BENSALEM TOWNSHIP

Township of Bensalem, Bucks County, Pennsylvania Notice of Appeal

Project:	SIGN
Project Address:	4869 STREET RD TREVOSE, PA 19053
Tax Parcel:	02-004-183
Property Owner:	SAME AS ADDRESSED
Permit Status:	APPLICATION DENIED

**PROPOSED DIGITAL ADDITION TO EXISTING FREESTANDING SIGN
TREVOSE ANIMAL HOSPITAL
4869 STREET ROAD
TREVOSE, PA 19053
PLAN, ELEVATION & DETAILS**

Proposed addition to existing freestanding sign located at Trevoise Animal Hospital, 4869 Street Rd, Trevoise, Pa. 19053

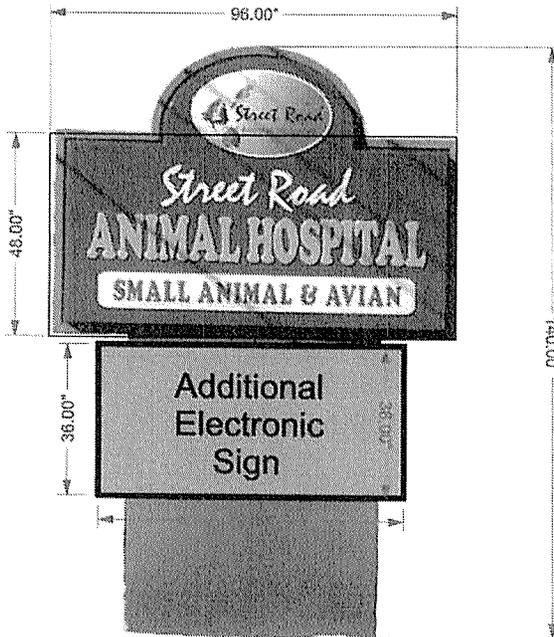
ALL COMMERCIAL DRAWINGS SHALL BE SIGNED AND SEALED BY A PENNA REGISTERED DESIGN PROFESSIONAL.

PROVIDE TYPE OF ATTACHMENT OF SIGN TO EXISTING SUPPORT.

LED message boards are not permitted. [Section 232-714(7)h.]

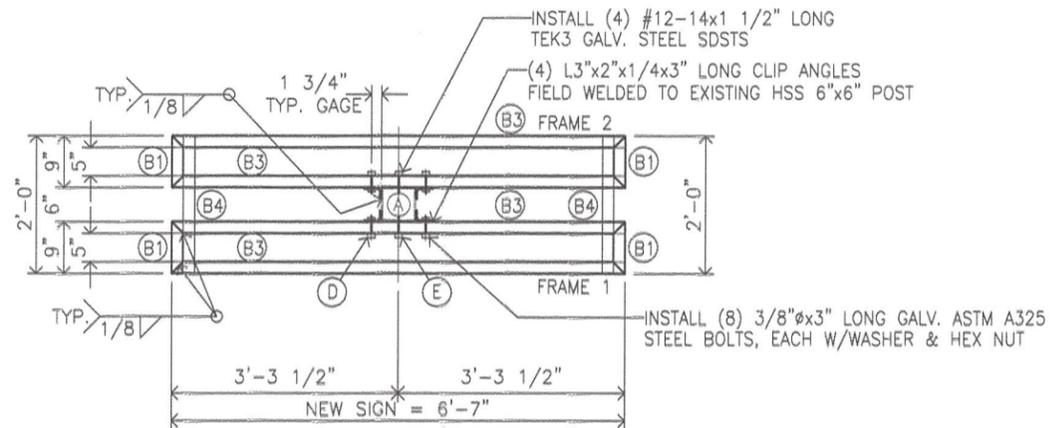
- Author: sterlecki Subject: Text Box Date: 2/11/2016 9:07:06 AM
PROVIDE TYPE OF ATTACHMENT OF SIGN TO EXISTING SUPPORT.
- Author: sterlecki Subject: Text Box Date: 2/11/2016 9:07:03 AM
ALL COMMERCIAL DRAWINGS SHALL BE SIGNED AND SEALED BY A PENNA REGISTERED DESIGN PROFESSIONAL.
- Author: rjans Subject: ZONING REJECTED Date: 2/11/2016 8:35:11 AM
- Author: sterlecki Subject: BUILDING REJECTED Date: 2/11/2016 9:07:09 AM
- Author: rjans Subject: Text Box Date: 2/11/2016 8:39:38 AM
LED message boards are not permitted. [Section 232-714(7)h.]
